REFERENCE: Chapter 2: Manitoba's Preferred Development Plan Facilities; Section: 2.1.3.3; Page No.: 26

1 **REFERENCE: Chapter 2: Manitoba's Preferred Development Plan Facilities; Section:**
2 **2.1.4.1; Page No.: 32**

Figure 1. EMERGENCY ENERGY AVAILABLE
EXCLUDING NON-FIRM ON-PEAK IMPORTS

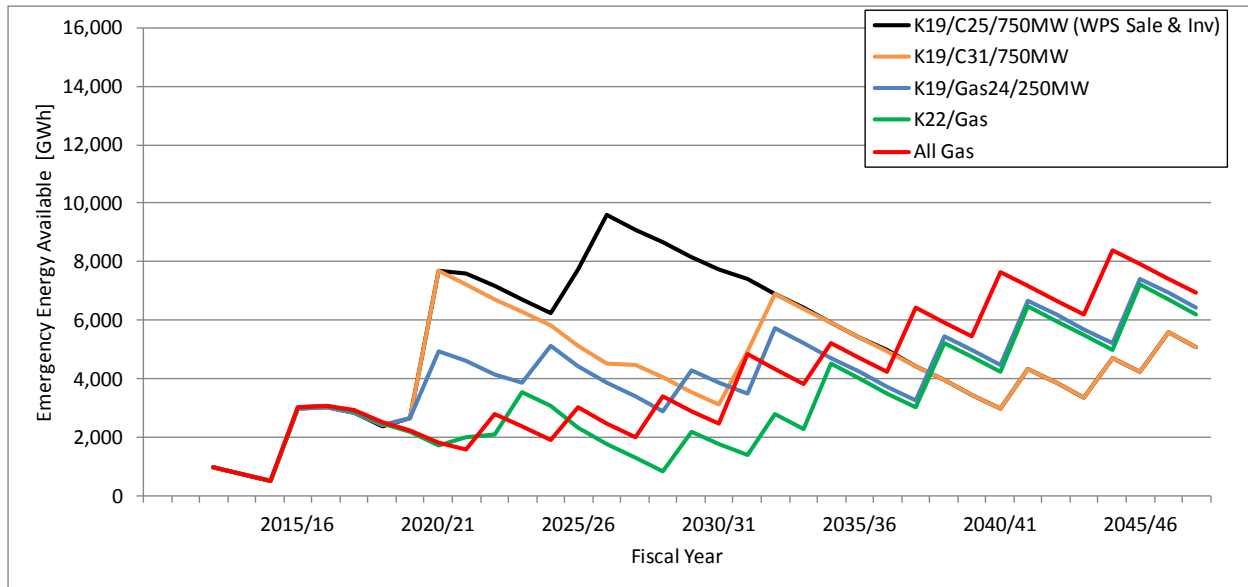
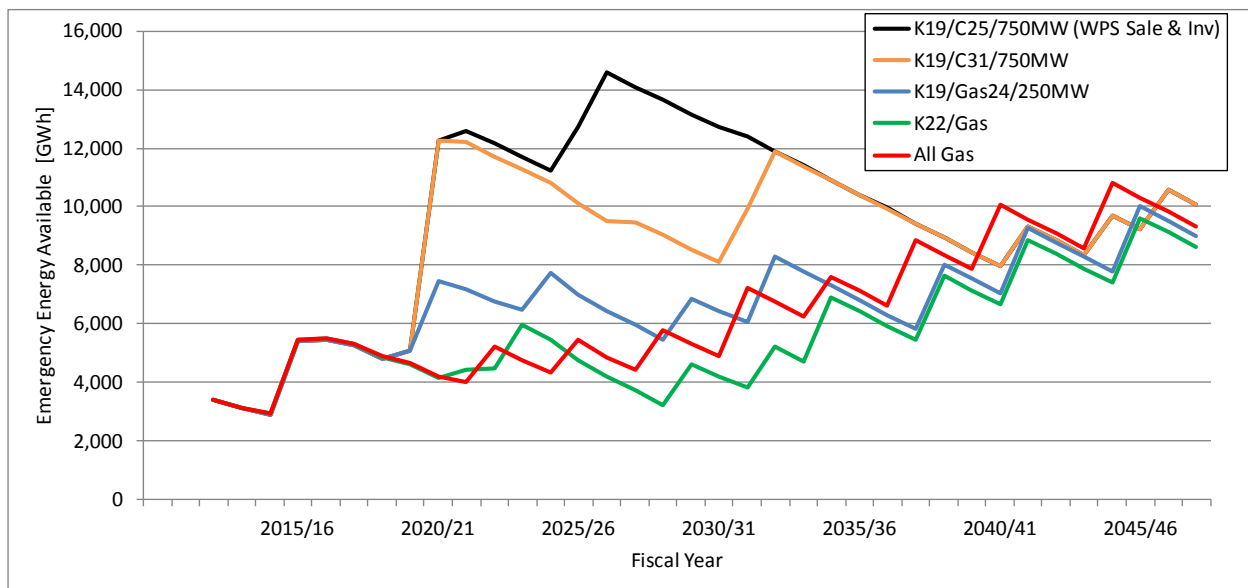
5 The Preferred Development Plan offers customers more security against the risks of extreme
6 drought. What is the expected probability of extreme drought included in the MA-BCA and to
7 what extent have climate change impacts been considered in the future probability?

- 1 The attached document provides further detailed quantification and comparison of the
- 2 emergency energy additional to dependable energy that is associated with certain key
- 3 development plans.

Figure 1 shows that, when the non-firm on-peak imports are excluded, the plan with Conawapa G.S. in 2031/32 provides, over the 20 year period starting with the 2019/20 Keeyask G.S. in-service date, an average of between approximately 1,000 GWh/year and 2,500 GWh/year more emergency energy compared to the All Gas, K22/Gas and K19/Gas24/250MW Plans. Alternatively when Conawapa is advanced in the Preferred Plan this range grows to average between approximately 2,500 GWh/year and 4,000 GWh/year.

Figure 2 shows that, when the non-firm on-peak imports are included, the plan with Conawapa G.S. in 2031/32 provides, over the 20 year period starting with the 2019/20 Keeyask G.S. in-service date, an average of between approximately 3,000 GWh/year and 5,000 GWh/year more emergency energy compared to the All Gas, K22/Gas and K19/Gas24/250MW Plans. Alternatively when Conawapa is advanced in the Preferred Plan this range grows to average between approximately 4,500 GWh/year and 6,500 GWh/year.

In general, the two development plans that include the new 750MW interconnection and construction of Conawapa G.S. have more emergency energy available in the medium-term than the other plans, which generally include large quantities of new thermal generation. This difference narrows and, when
